## **FURR STREET PARTNERS SUBDIVISION**

Engineering Comments: FINAL PLAT COMMENTS (should be addressed prior to submitting the FINAL PLAT for review and/or signature by the City Engineer):

APPLICATION NUMBER 12 DATE October 1, 2020

# DETAIL SITE PLAN

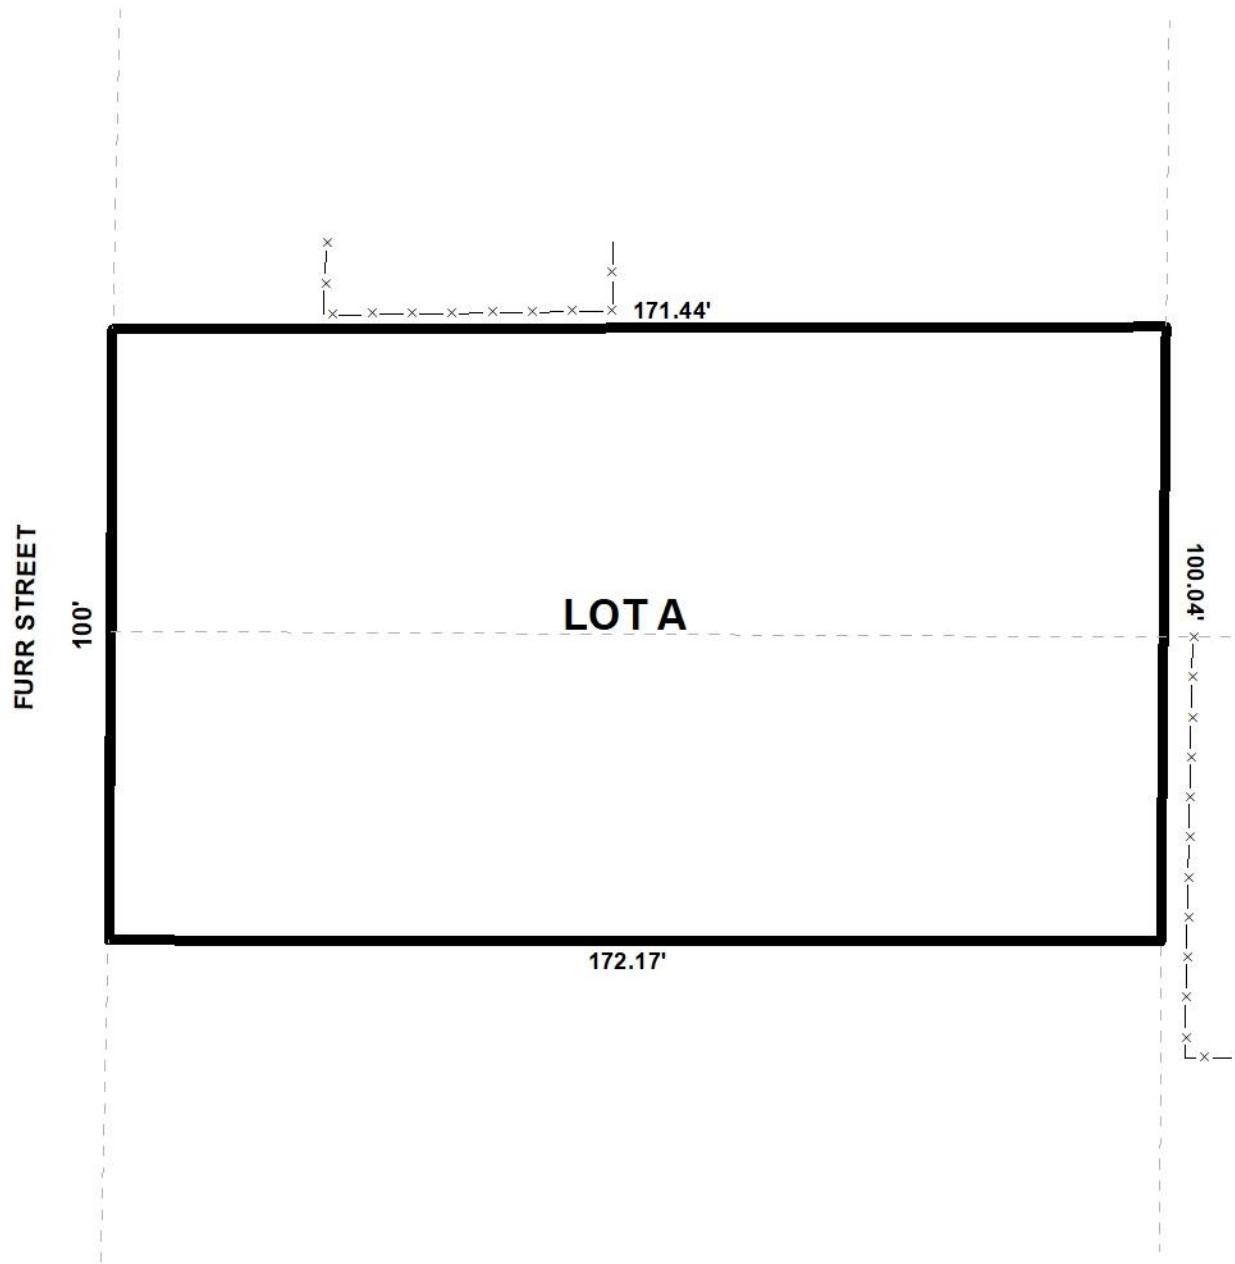
The proposed lot fronts Furr Street, a minor street with curb and gutter. The right-of-way width of Furr Street is not indicated on the preliminary plat. Therefore, the plat should be revised to provide the right-of-way width of Furr Street on the Final Plat, and if less than 50', dedication should be required to provide 25' from the centerline of Furr Street.

The preliminary plat does not indicate a front minimum building setback line. Therefore, the plat should be revised to indicate a front minimum building setback line as measured from the current right-of-way line, or adjusted to be measured from any required frontage dedication.

- 1) revision of the plat to provide the right-of-way width of Furr Street on the Final Plat, and if less than 50', dedication to provide 25' from the centerline of Furr Street;
- 2) retention of the lot size label in both square feet and acres on the Final Plat, adjusted for any required frontage dedication, or the furnishing of a table on the Final Plat providing the same information;
- 3) revision of the plat to indicate a front minimum building setback line as measured from the current right-of-way line, or adjusted to be measured from any required frontage dedication;
